Charlotte-Mecklenburg Planning Department

SUBJECT: Administrative Approval for Petition No. 1989-096 The Flad Mullinax Partnership

PROJECT NAME: U.S. FOODS - EASTWAY EXPANSION

U.S. FOODS

ADMINISTRATIVE APPROVAL PLAN PETITION # 1989-096AA

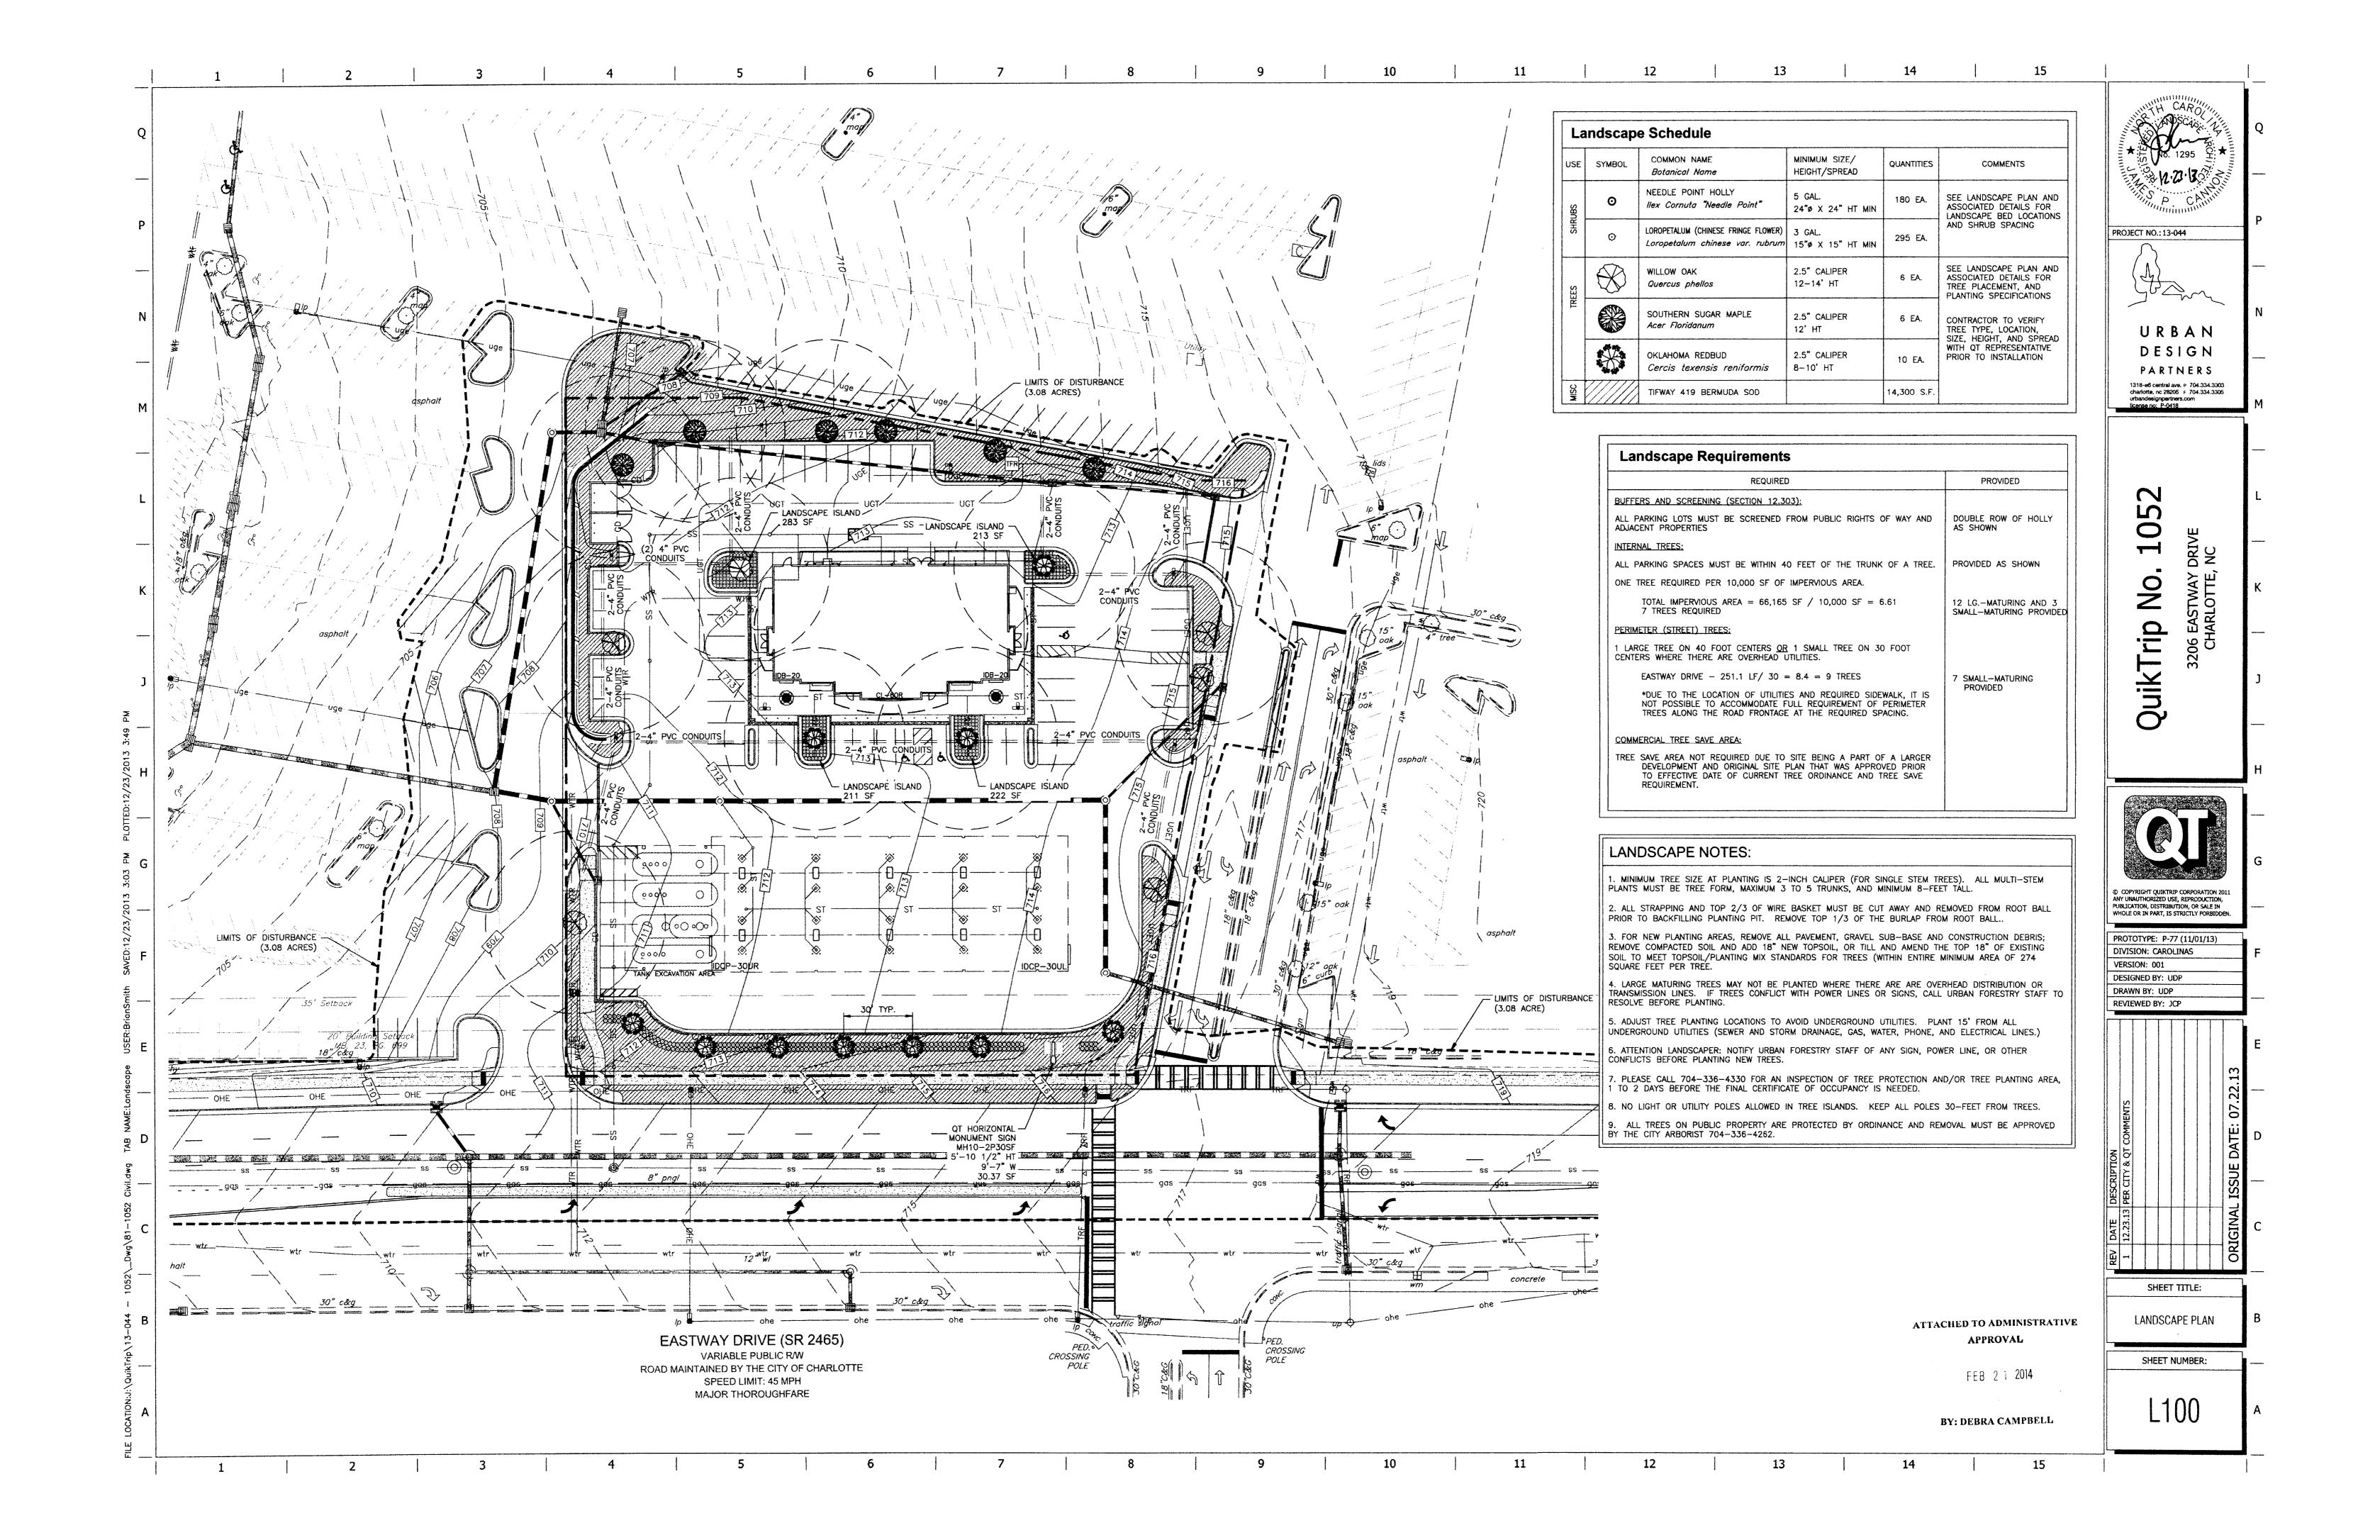
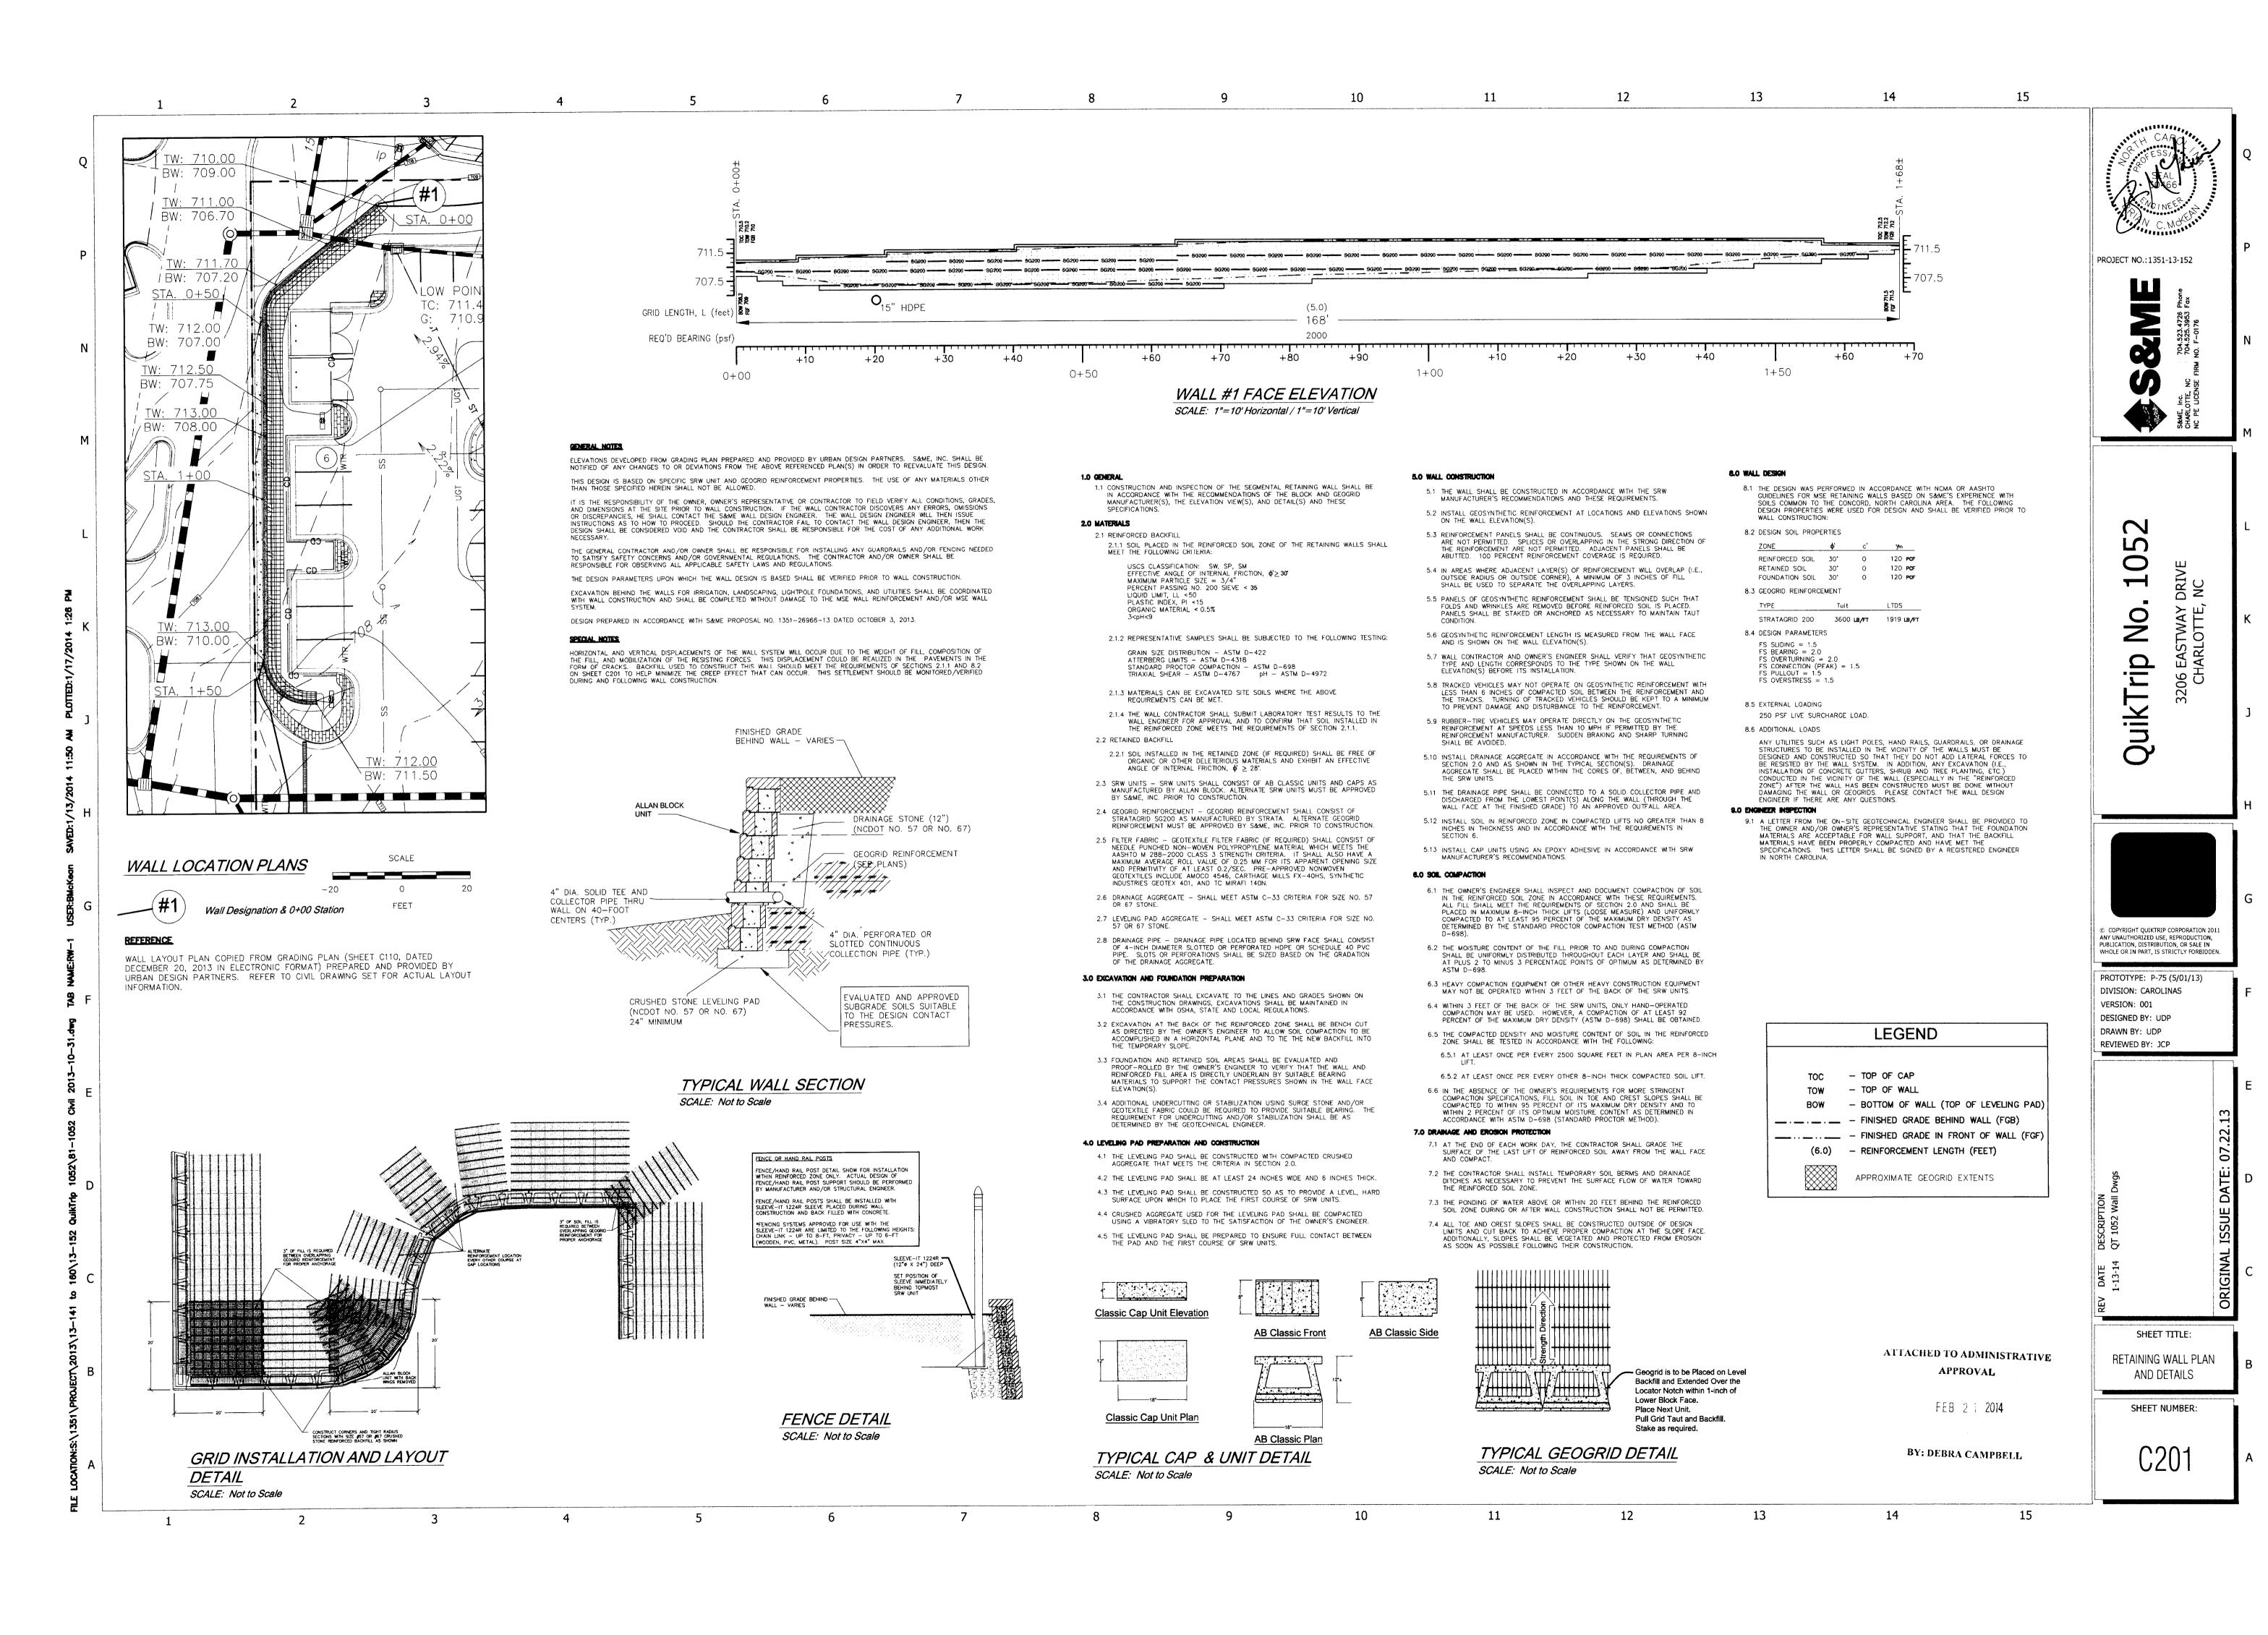
Attached are revised site plans and elevations for the proposed 5,773 square foot convenience store and new outparcel. Since these changes do not alter the intent of the development and meet the requirements of the conditional site plan, I am approving these plans. Please use these plans when evaluating requests for building permits and certificates of occupancy.

- The new proposed driveway access along Eastway Drive will need to be approved by North Carolina and Charlotte Department of Transportation.
- All other Zoning, Subdivision, Tree Ordinance and conditional requirements still apply.
- Signage was not a part of this review.

SITE PLAN

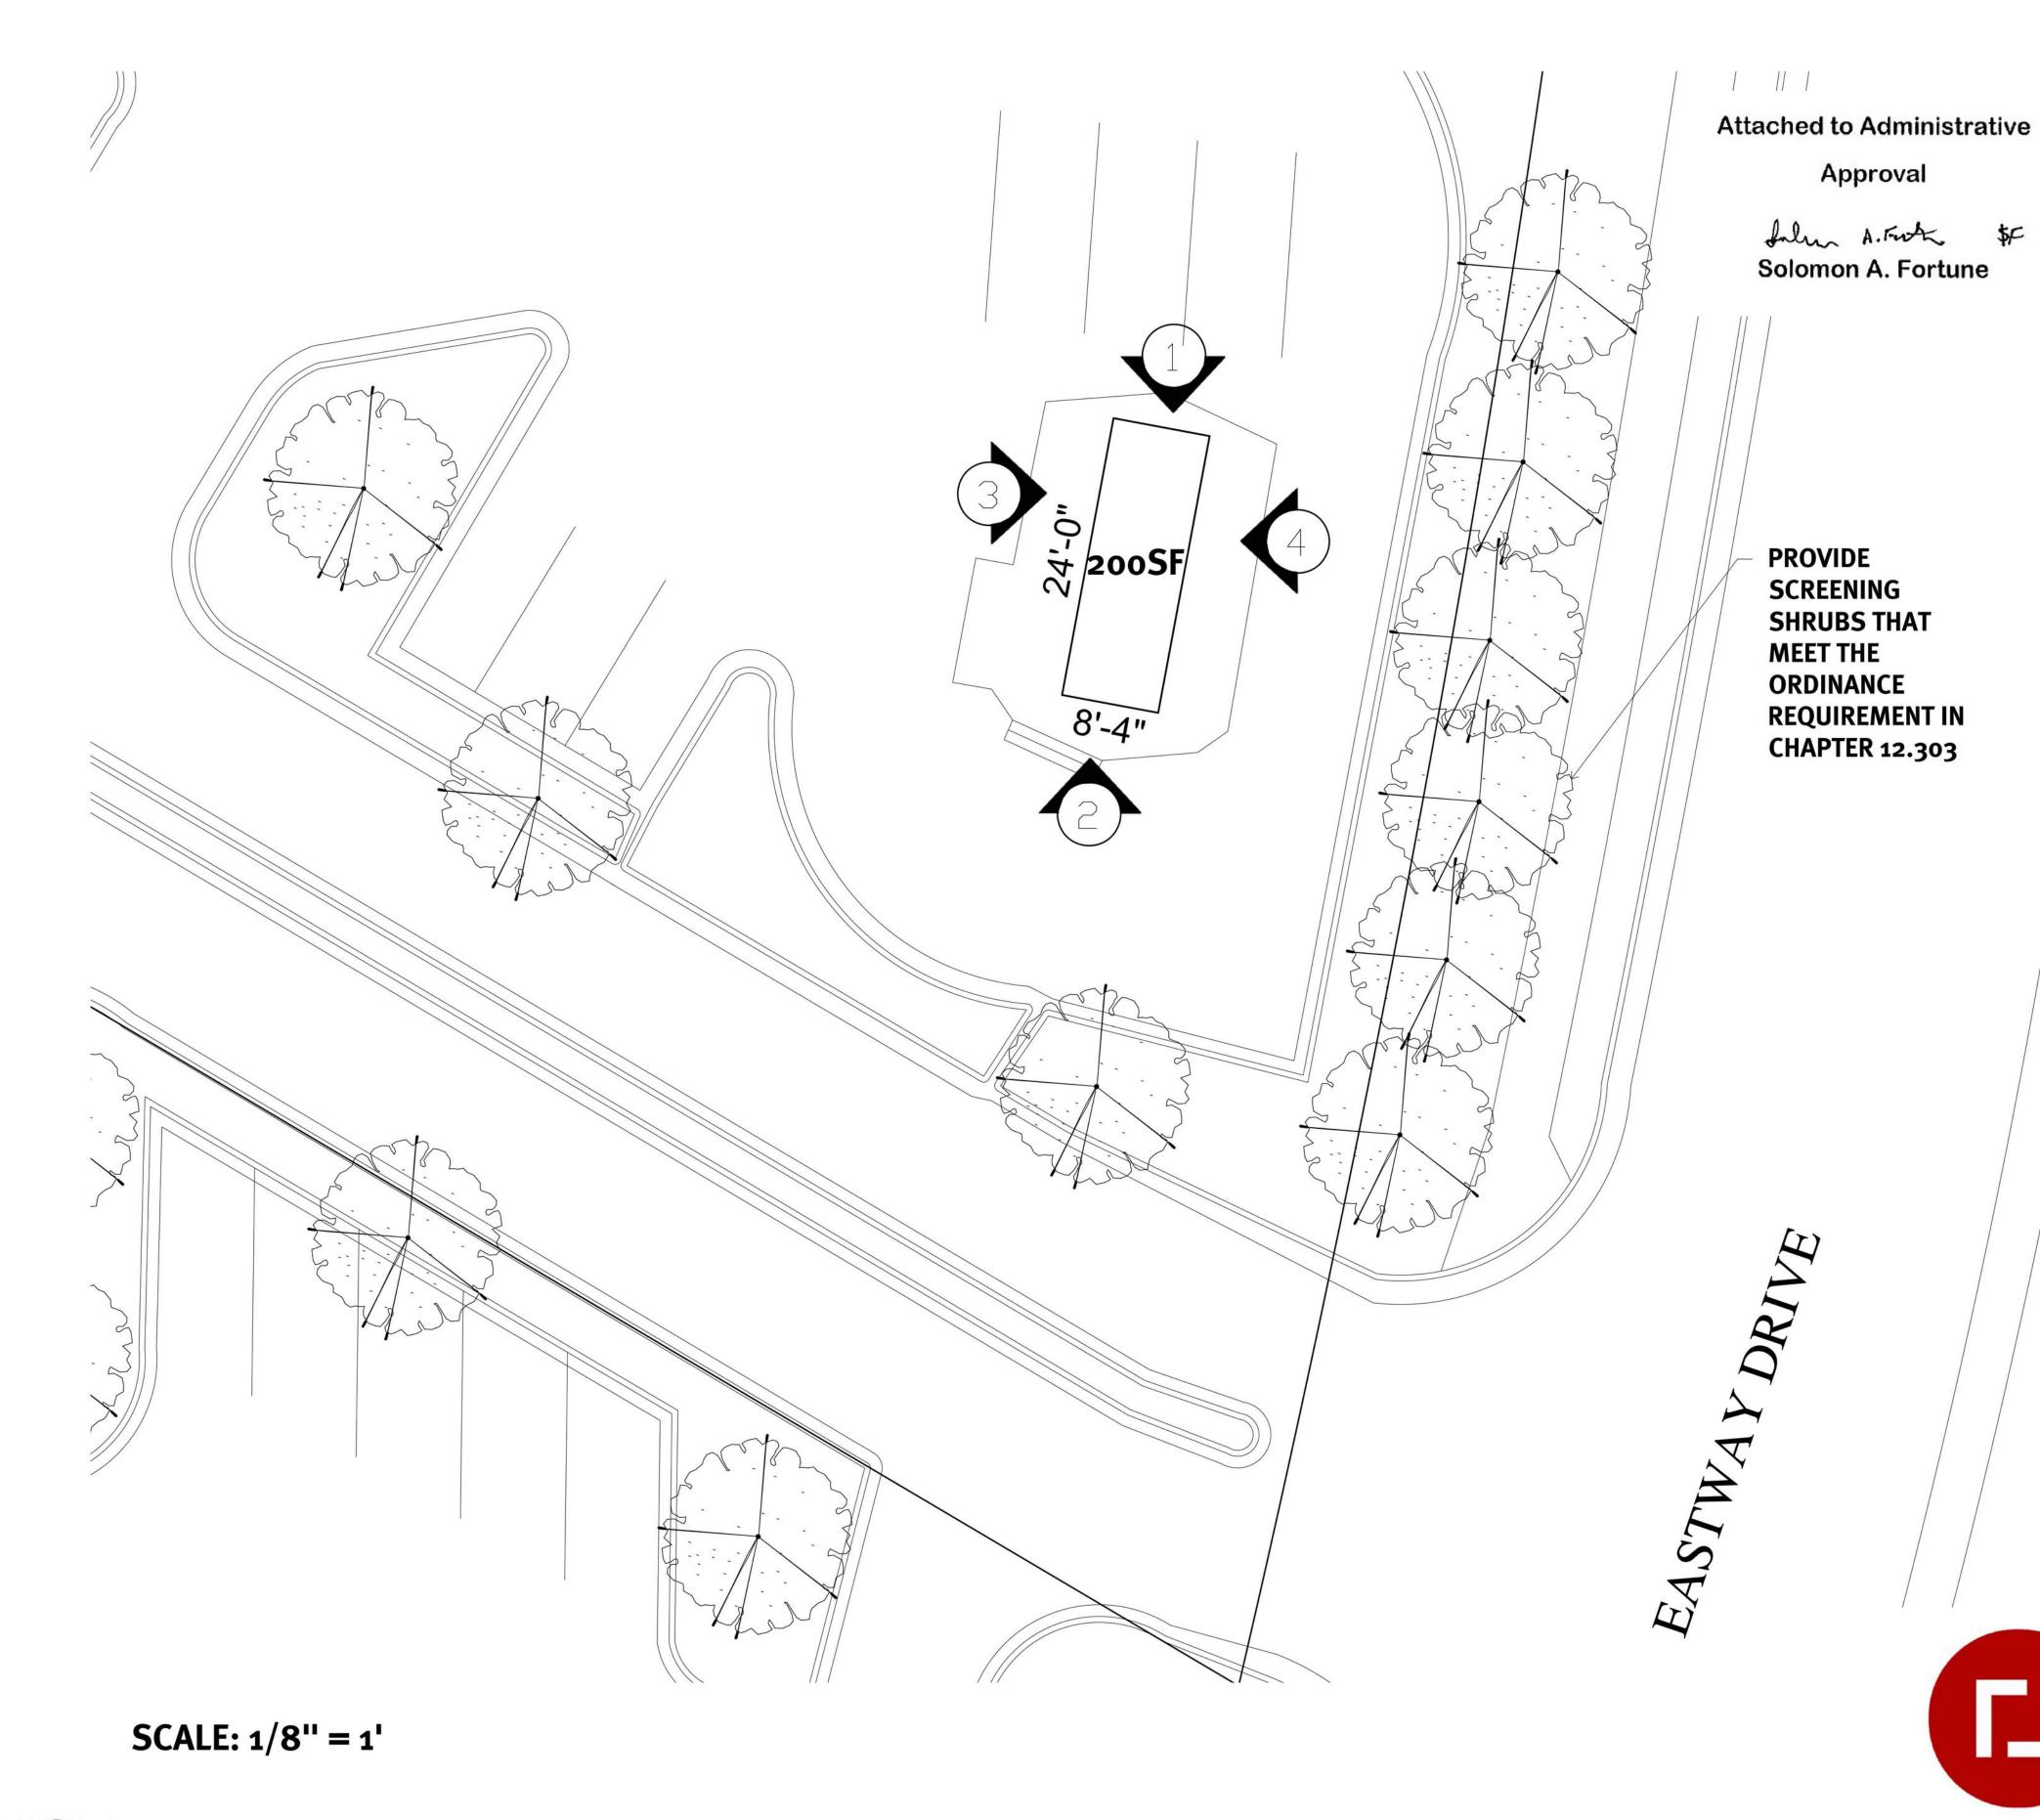
- Elevations for an accessory retail use (Ice House).
- Site layout plan and landscaping.

NOTE: NO EXISTING PARKING SPACES ARE BEING REMOVED FOR THIS PROPOSED STRUCTURE
